# Access Compliance Report

## Public Rights-of-Way

### (Pedestrian Signals)

| ADA ID: BE2689F84C5E                    | Signal Type: Two Push Buttons-Non APS | Overall Compliance: No                  | Severity Score: BTN 1:N/A BTN 2: N/A No BTN: N/A |

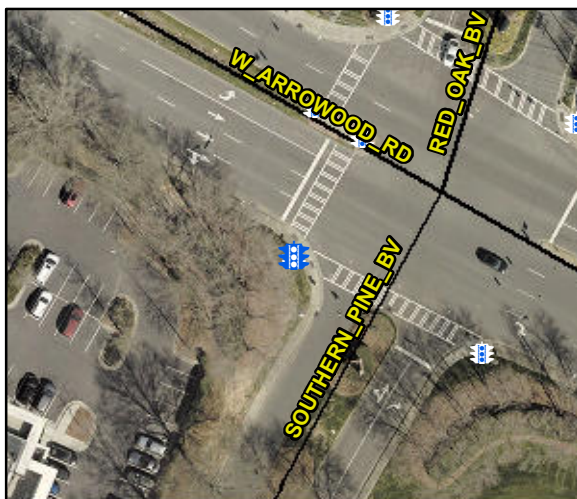
Possible Solutions: Replace Signal Push Button With APS Button on New Post. Remove & Relocate Sign.

PROW/ADA: TMUTCD 4e.08, R404.2, R404.3, R406.2, R404.7.3

| Compliance | Description                             | Data    | Compliance | Description                            | Data |
|------------|-----------------------------------------|---------|------------|----------------------------------------|------|
| Yes        | B 1 PARA Approach Reach (in)            | 9.0     | No         | B 2 PARA Approach Reach (in)           | 14.0 |
| No         | B 1 Clear Floor Space Slope (%)         | 4.6     | No         | B 2 Clear Floor Space Slope (%)        | 4.2  |
| No         | B 1 Clear Floor Space XSlope (%)        | 3.1     | No         | B 2 Clear Floor Space XSlope (%)       | 4.8  |

| No  | B 1 DistanceTo Curb (in)  | 93.0          | No  | B 2 DistanceTo Curb (in)  | 93.0          |
